Groundwater & Wastewater Services
Septic Project File & Data Review Worksheet

SEPTIC SYSTEM DESIGN REVIEW WORKSHEET

RE: Request for an Improvement Permit for Lot 2 off of Sample Road.
MCHD File #6740B

SOIL/SITE EVALUATION
for ON-SITE WASTEWATER SYSTEM

Scale: 1 inch equals 50 feet	S&ME	Faison-Sample Road, LLC	FIGURE
Drawn by: JBP		Lot 2	1
Reviewed by: Jeremy P. Michelone, RS		Mecklenburg County, NC	
Date: February, 2007	ENVIRONMENTAL SERVICES · ENGINEERING · TESTING	S&ME Project #1588-05-091

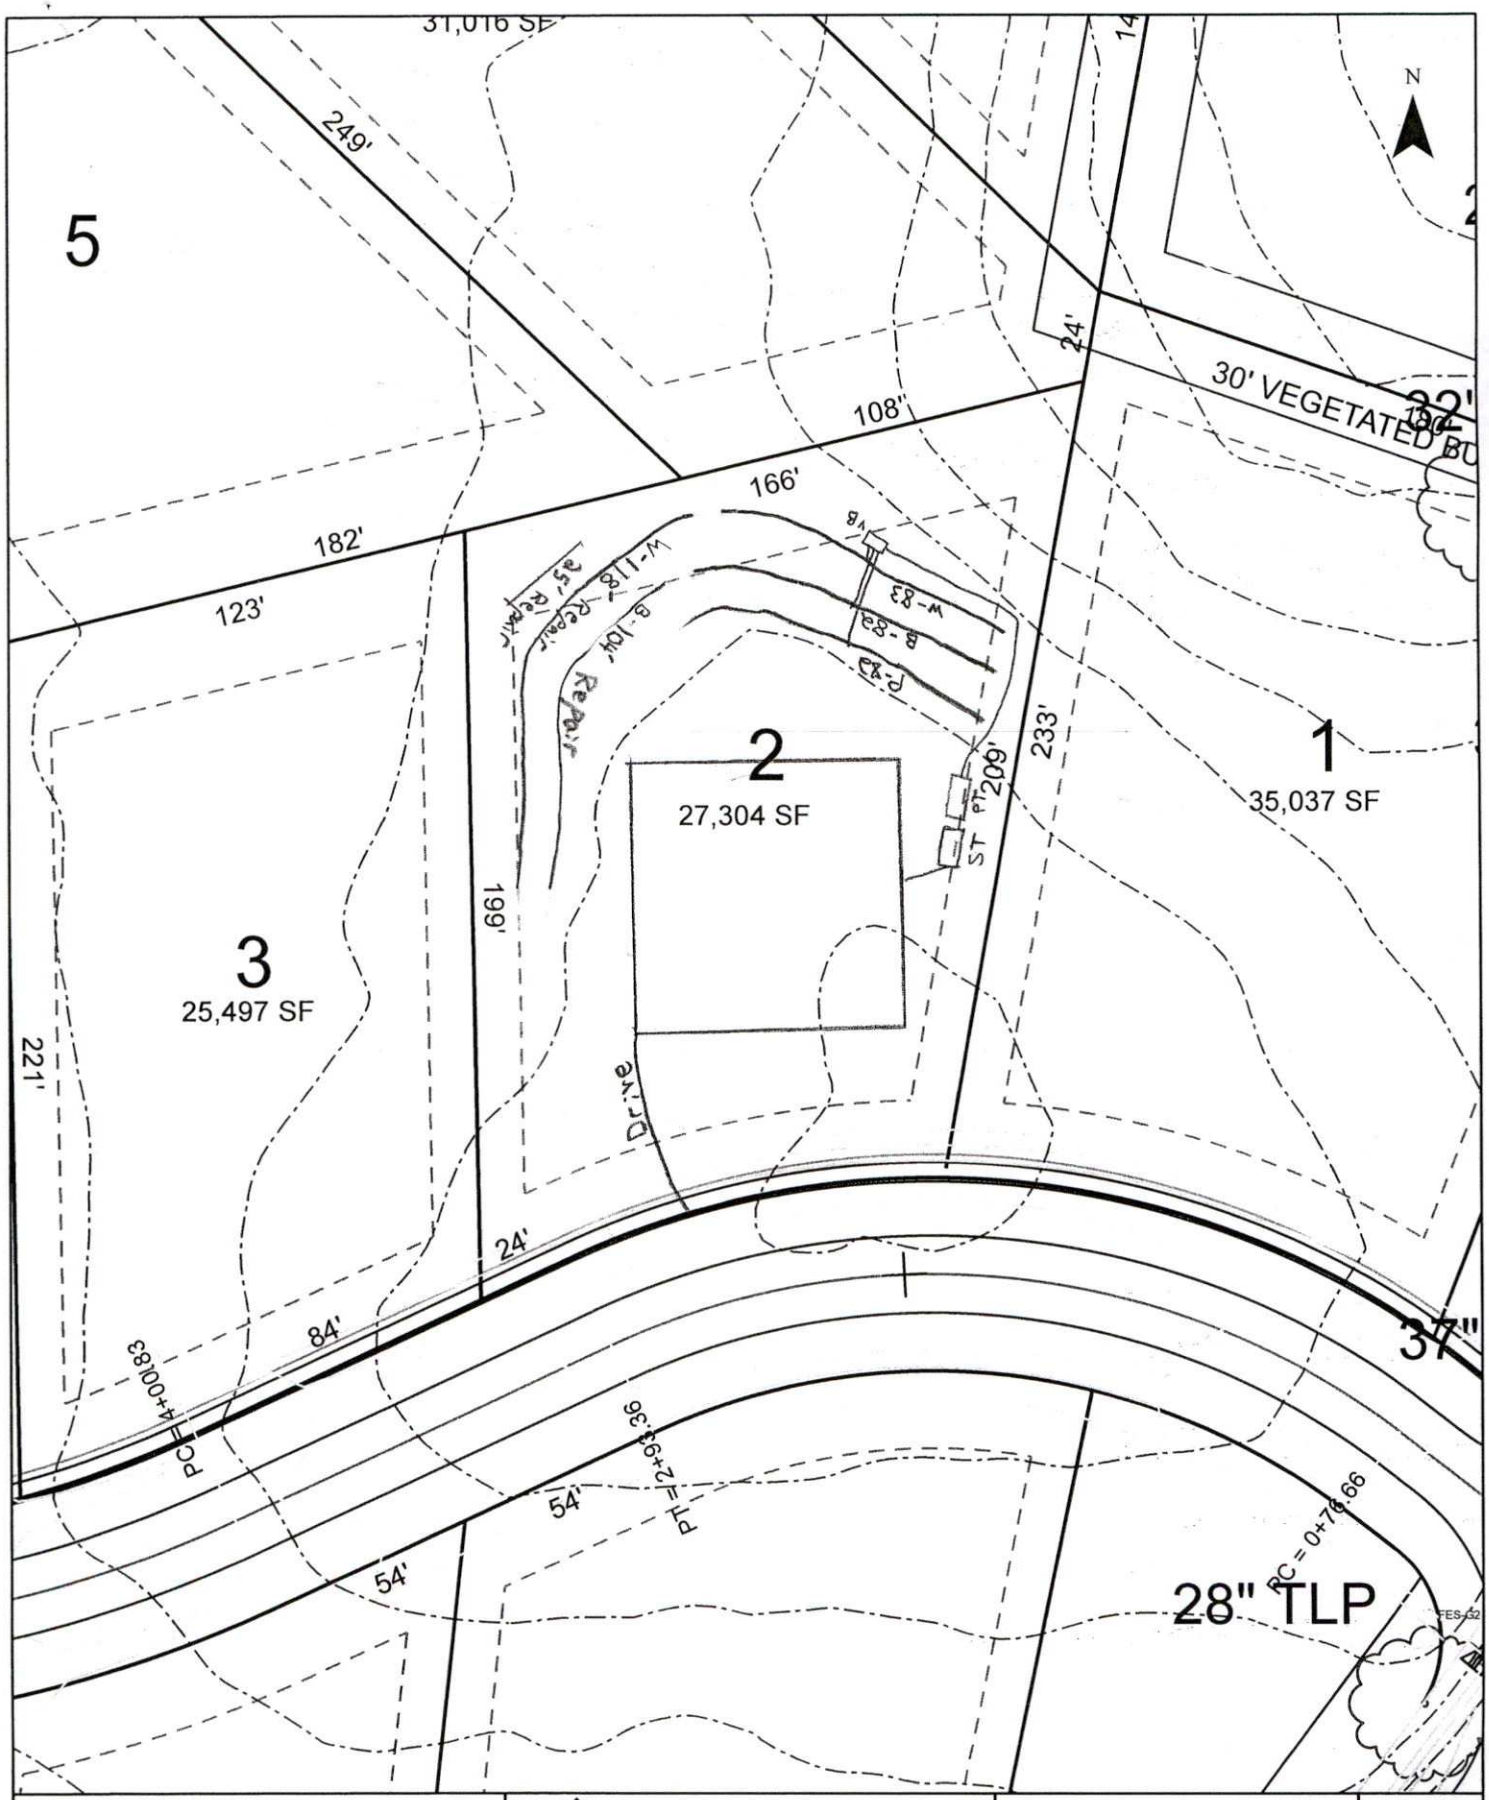
Please review the attached system sketch and design specifications for the Improvement Permit. Any additions or revisions you feel are necessary can be made on the Improvement Permit. Please call if you have questions or comments.
